DRAINAGE AND TRANSPORTATION INFORMATION SHEET (REV 6/2018)

**LOT 4, BLOCK 5
 UNSER CLIFFS SUBDIVISION**

MARTINEZ - LOT 4 GRADING & DRAINAGE PLAN

RE: **Lot 2 Block 5, Unit 5, S.A.D. 227**
Volcano Cliffs Subdivision
6512 Onyx Ct. NW
Grading and Drainage Plan
Engineers Stamp Date: 1/3/20 (E10D071)
Pad Certification Date: 1/14/20

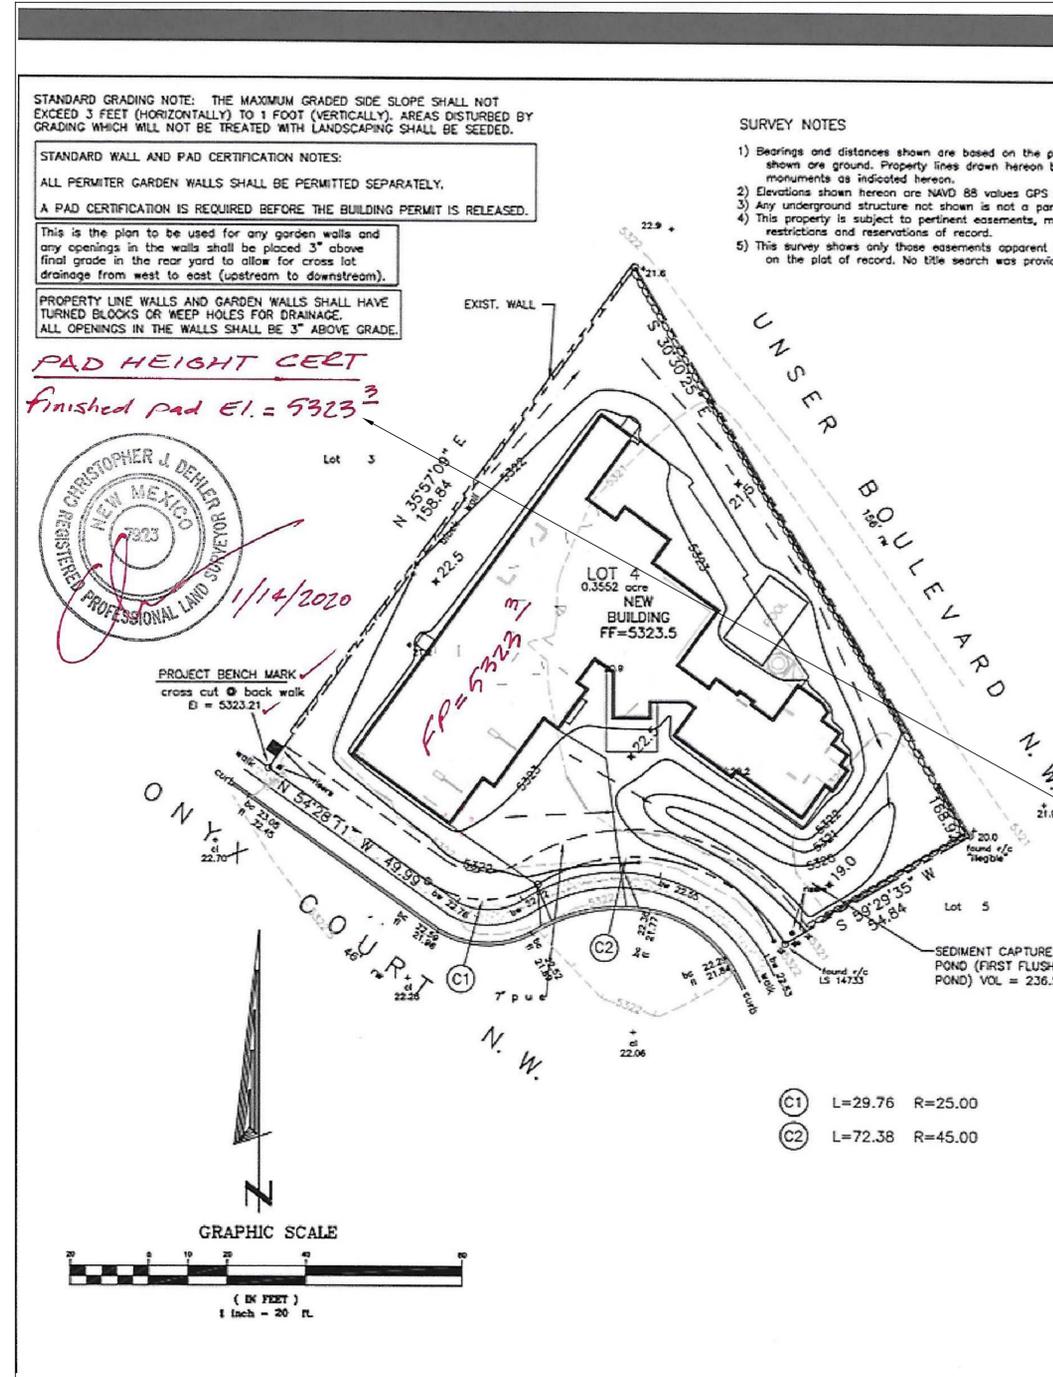
Based upon the information provided in your submittal received 2/7/20, this plan is approved for Building Permit.

Please have the owner/builder attach a copy of this approved plan, to the construction sets in the permitting process prior to sign-off by Hydrology.

Reiterate to the Owner/Contractor that a separate permit for any garden/retaining wall must be obtained, with the approved G&D plan dated 12/4/18.

Prior to Certificate of Occupancy release, Engineer Certification per the DPM checklist of this plan will be required. A fee of \$75.00 will be charged for this certification. If an additional resubmittal is required a \$75.00 fee for each resubmittal will be charged.
